# DESIGN CHANGE

## AFFECTING TENSIONING PULLEY 56135

TECHNICAL INFO NO. 1092

Land Rover	Freelander
MG	ZR, ZS
Rover	25

**Figure 1:** Previous design (left),  
and new design (right)

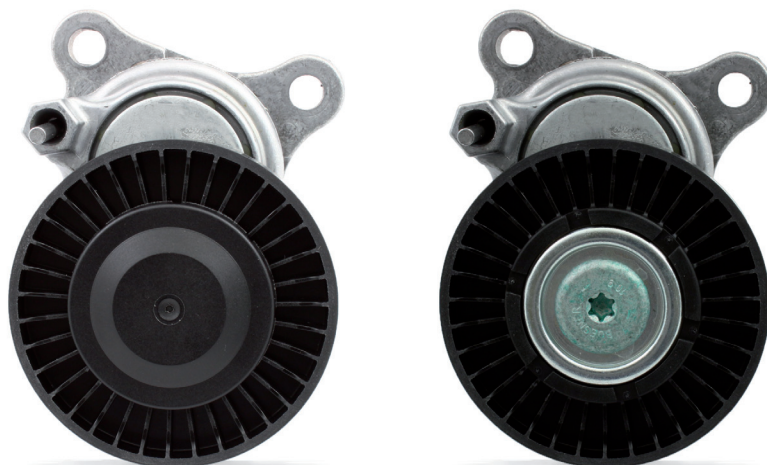
As part of our continuous efforts to improve our products, modifications have been made to the tensioning pulley with part number 56135.

This Technical Information sheet shows the visual features of the previous version (Figure 1, left) and the new version (Figure 1, right).

During the transition period, we may have mixed stocks of both types.
